Parking Lot Specialties Expansion – Site Plan

City of Carlisle, Iowa

FOX Engineering & City Staff have completed the second review for the Parking Lot Specialties Site Plan submittal dated 11/9/21 and submitted by email on 11/10/21 and offer the following comments:

Parking Lot Specialties – SITE PLAN - 210106

TOILET FIXTURE AND ACCESSORY LAYOUT ELEVATIONS

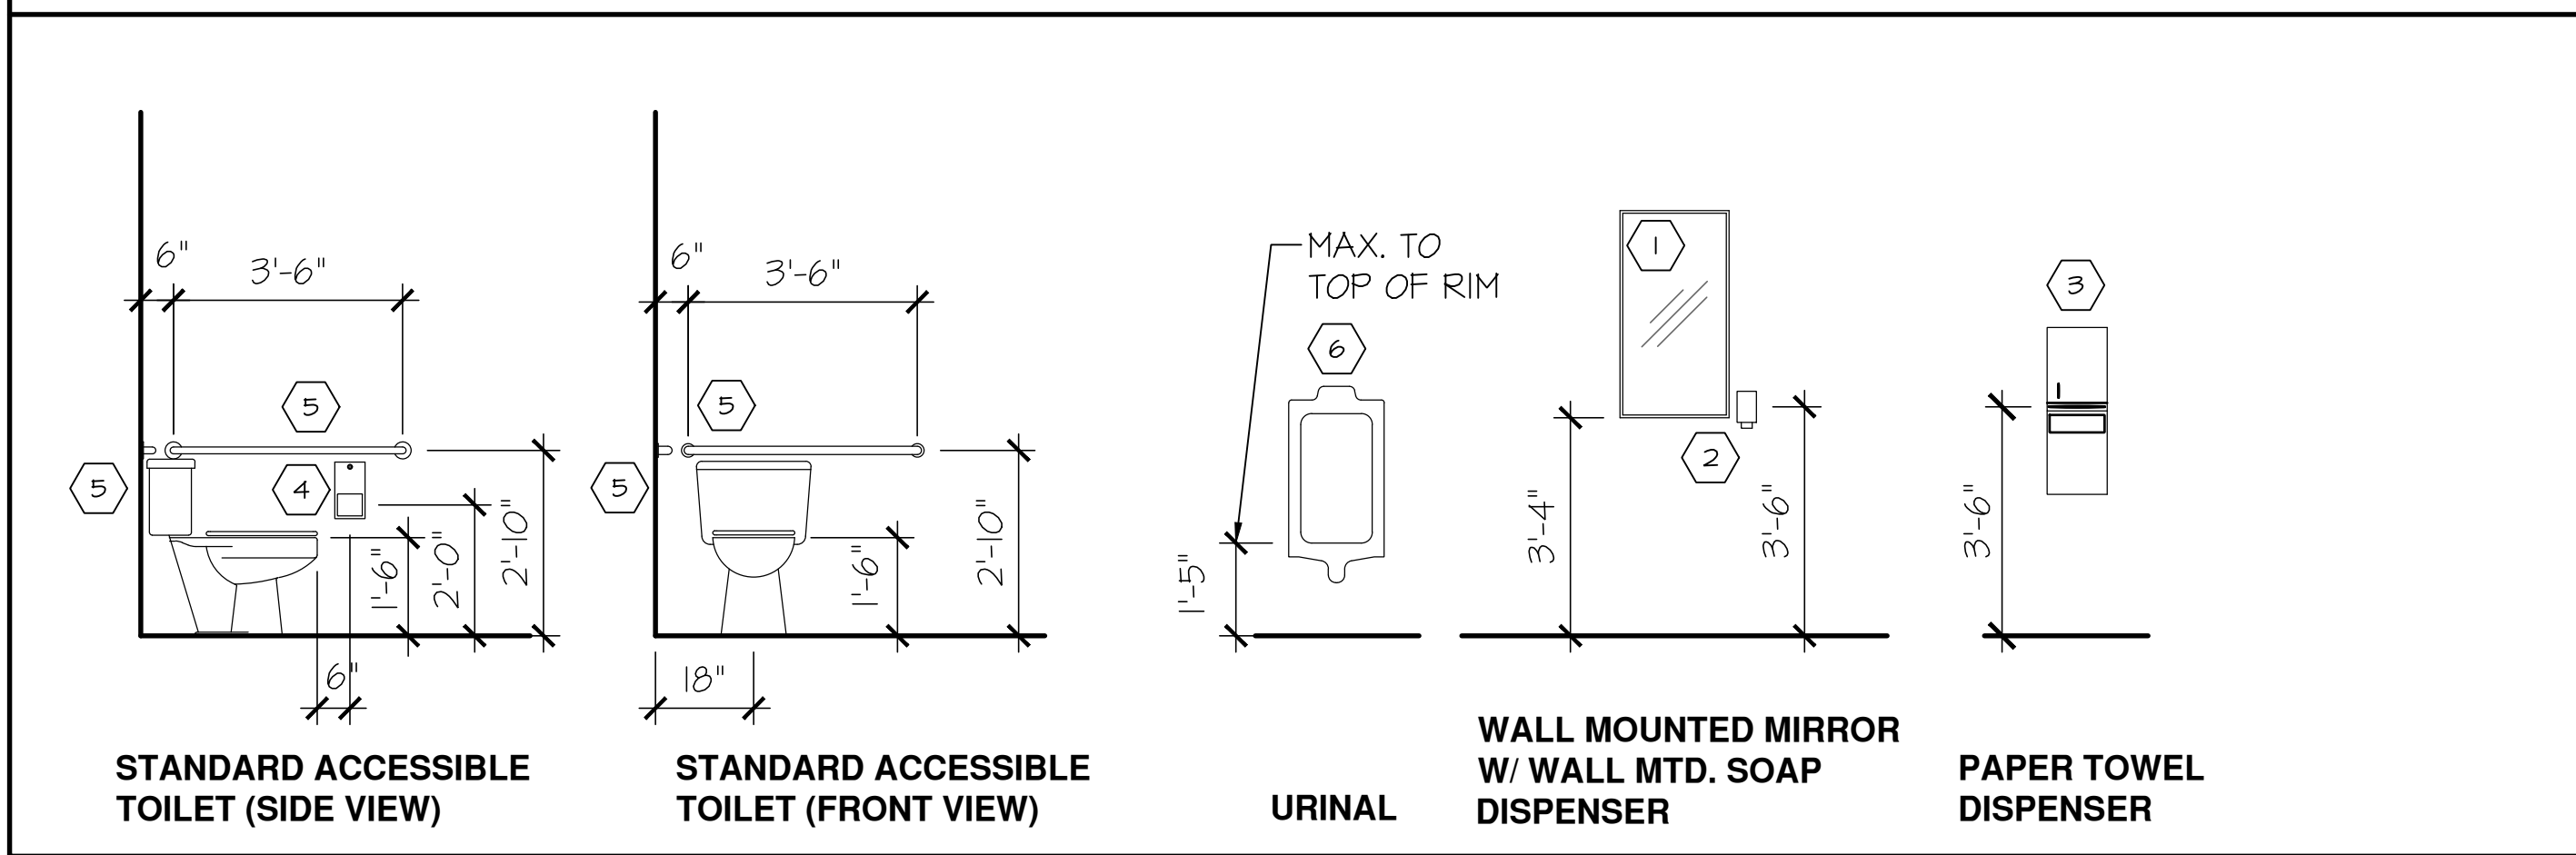
14. The west elevation shows a man door (NW corner) that is not shown on the site plan. Please revise as necessary.
15. Please state the color and type of building materials for all structures. Please clarify that this building will match the first structure.
16. It is highly recommended that you bring detailed building materials and color schemes with you to P & Z and Council for discussion.

32. The elevations have been corrected
33. The Owner will provide more information regarding color and building materials
34. We understand it is highly recommended to bring detailed building materials and color schemes to P&Z and Council for discussion
